TEMPORARY ABANDONMENT WELL APPLICATION

Re: Temporary Abandonment
API 15-067-20370-00-01
Cooper C 2
NE/4 Sec.32-27S-35W
Grant County, Kansas

Your application for Temporary Abandonment (TA) for the above-listed well is denied for the following reasons(s):

Group: Merit Energy Company-Ulysses Well: Copper C-2 (acquired on: 07/30/21 08:18:41)

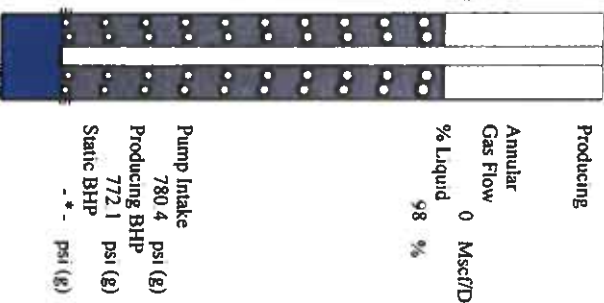
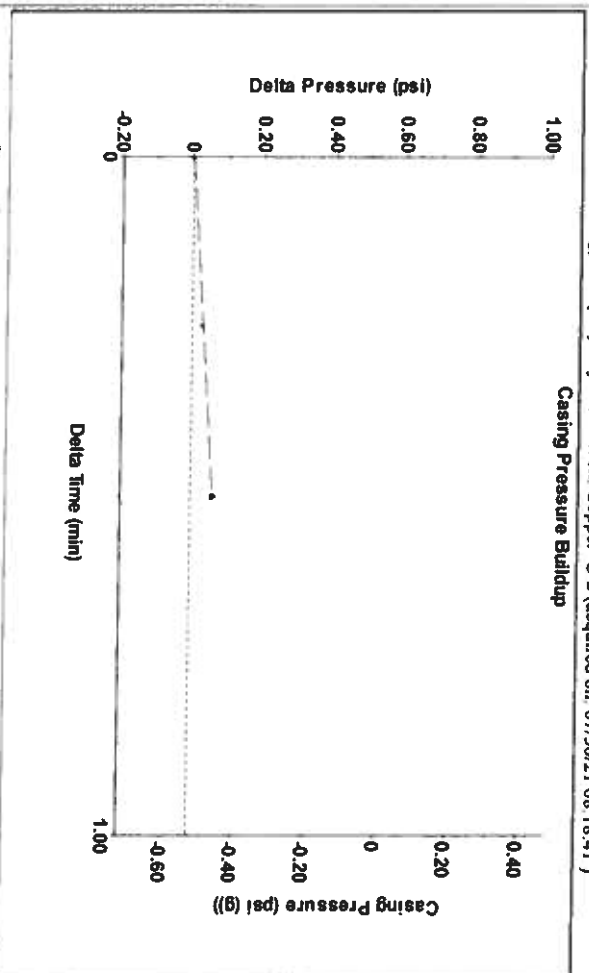
High Fluid Level

Pursuant to K.A.R. 82-3-111, the well must be plugged, or returned to service, or obtain temporary abandonment status by 09/04/2021.
